UNITED STATES PATENT AND TRADEMARK OFFICE

APPLICATION NO.	FILING DATE	FIRST NAMED INVENTOR	ATTORNEY DOCKET NO.	CONFIRMATION NO.
10/661,695	09/12/2003	Daniel Saxer	HQ-6730	7362
26294	7590	08/28/2006	EXAMINER	
TAROLLI, SUNDHEIM, COVELL & TUMMINO L.L.P. 1300 EAST NINTH STREET, SUITE 1700 CLEVEVLAND, OH 44114				KOCZO JR, MICHAEL
			ART UNIT	PAPER NUMBER
			3746

Office Action Summary	Application No.	Applicant(s)	
	10/661,695	SAXER ET AL.	
	Examiner Michael Koczo, Jr.	Art Unit 3746

DETAILED ACTION

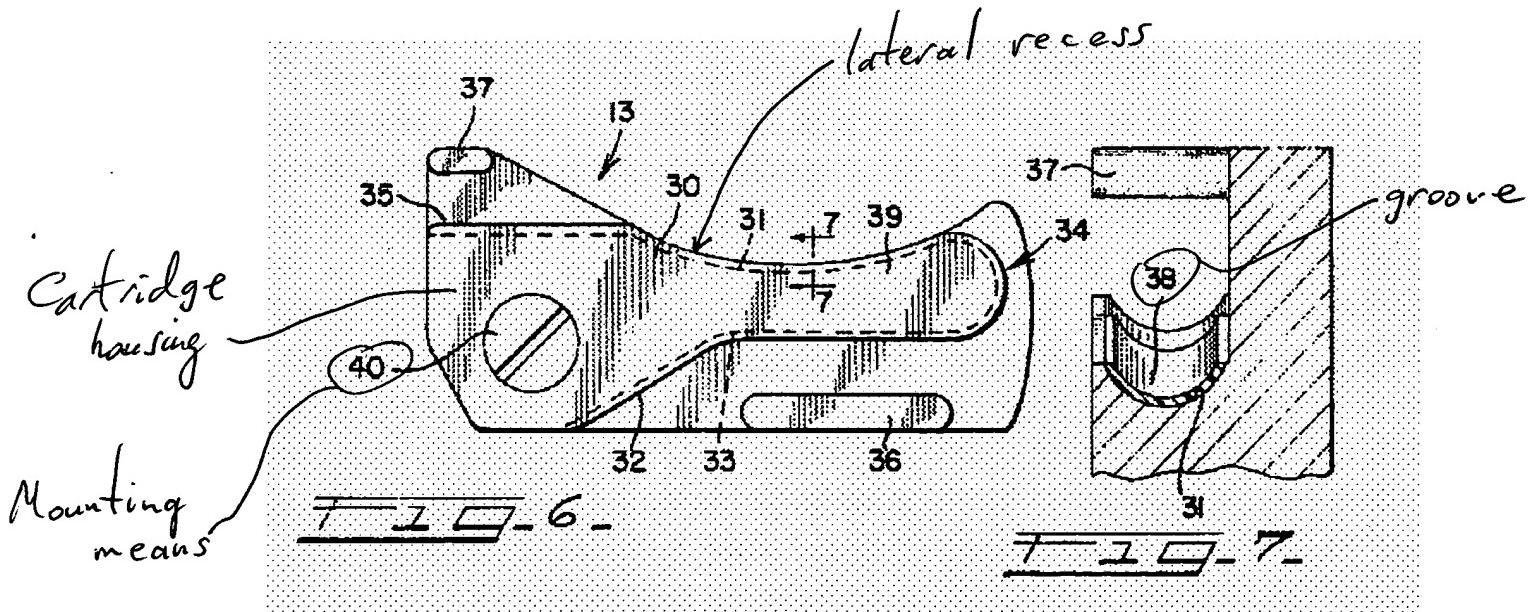
Claims 1 and 2, as understood, are rejected under 35 U.S.C. 102(b) as being anticipated by Adams. See annotated figures of Adams reproduced below.
